Compared with CG98GA, CG98GB only has an additional speaker, speaker wires, speaker interface, and the overall wiring is inconsistent. All other aspects are the same.	
The appearance and size	
HVIN: CG98GA	HVIN: CG98GB

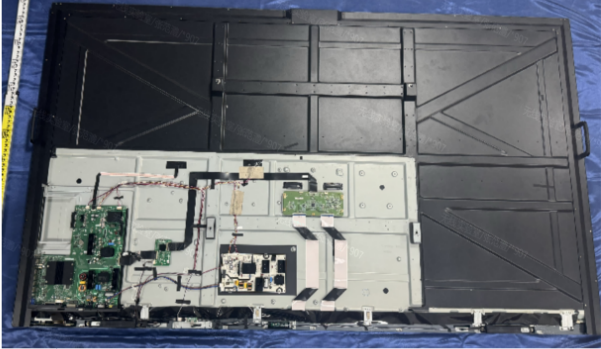
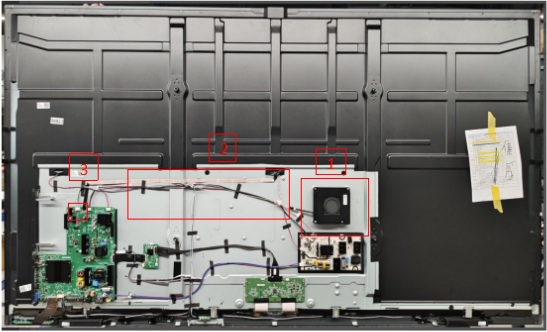
1 The CG98GB has an additional speaker compared to the CG98GA.	
2 The CG98GB has an additional speaker wires compared to the CG98GA.	
3 The CG98GB has an additional speaker interface on the motherboard compared to the CG98GA.	
4 The overall wiring of the prototype is inconsistent.
